AN HARLEY-DAVIDSON

SERVICE BULLETIN

M-830A (Replaces M-830)

COLOR-CODED CAM GEAR SELECTION

Figure 2. Cam Gear Fitting Procedure — 1000cc Models

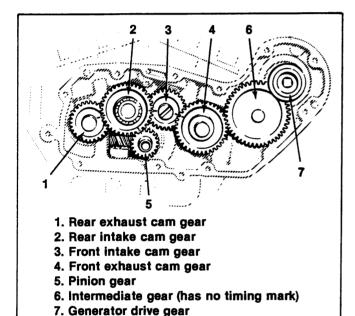
See Figure 2. In 1000cc engines which have four matched cam gears, increase the size of gears 1 and 3 (rear exhaust and front intake) by one color code and run engine to check for noise.

A size increase of gears 1 and 3 may be necessary, but no more than two size increases should be made before also increasing the size of gear 5. However, if a gear whine or howl is produced by a size increase, it indicates that there is not enough tooth clearance and the size of the affected gears must be reduced.

- 1. Measure gear size (diameter) over .105 in. dia. pins, Part No. HD-95632-79 using a micrometer caliper.
- 2. Select gear size to obtain proper tooth clearance for quietest operation. Gear rattle indicates fit is too loose (size is too small). Gear whine or howl indicates fit is too tight (size is too large).
- 3. As a procedure guide, increase or decrease size of gears 1 and 3 up to 2 color codes, then increase or decrease size of gear 5 corresponding amounts if necessary.

Figure 3. Cam Gear Fitting Procedure — 1200/1340cc Models

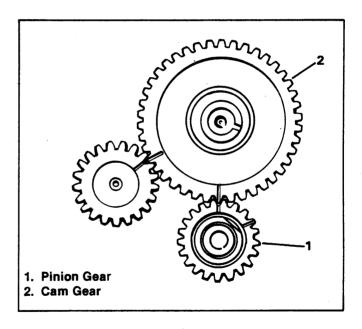
See Figure 3. The same process is used to reduce gear noise in 1200 and 1340cc engines. Increase the size of

the cam gear and pinion gear progressively by one color code to reduce gear rattle and decrease the gear size progressively to reduce whine.

- Measure gear size (diameter) over .105 in. dia. pins, Part No. HD-95632-79 using a micrometer caliper.
- Select gear size to obtain proper tooth clearance for quietest operation. Gear rattle indicates fit is too loose (size is too small). Gear whine or howl indicates fit is too tight (size is too large).
- Increase or decrease size of gears 1 and 2 one color code at a time to reduce noise.
